Product hierarchy no. *				Part no.	SBU	Type / Description	Customer part no.
SBU	PG	PUG	Type				
02	005	016	0000002219	See list below	Power Entry Modules w/o Filters	4719

Rating 10A@250VAC for UL and VDE added

Product Change Notification					PCN 4719		D10-037-633
owner	creation date	release date	released by	change order no	rev	page	
huberth	19.06.2019	09.07.2019	limachcl	2017856	A	1 of 1

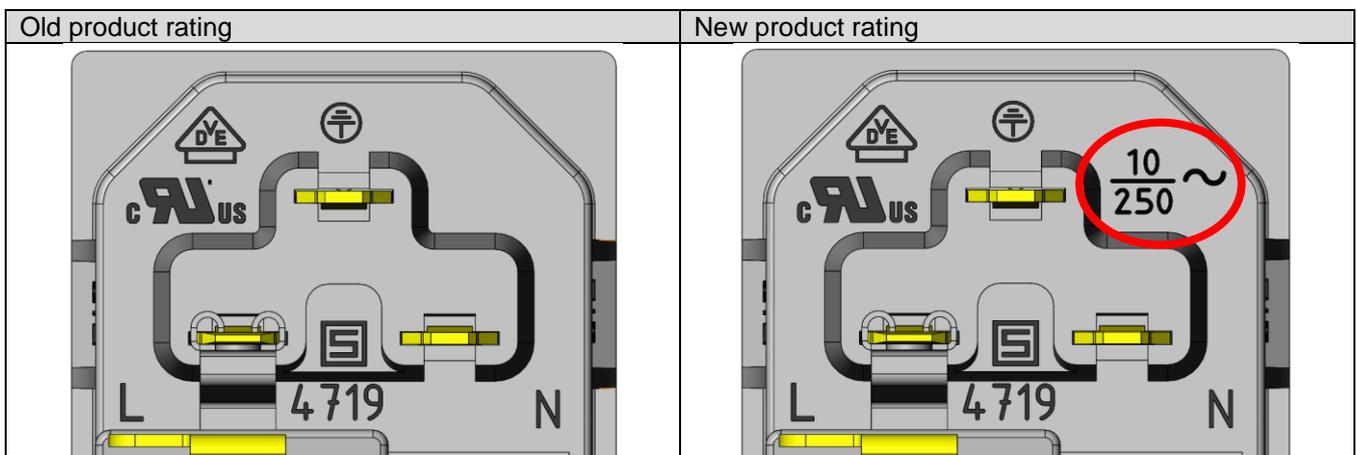
Form	Yes	Markings for the rating of UL and VDE added to moulding body
Fit	No	-
Function	No	-
Manufacturing	No	-
Label	No	-
Packaging	No	-
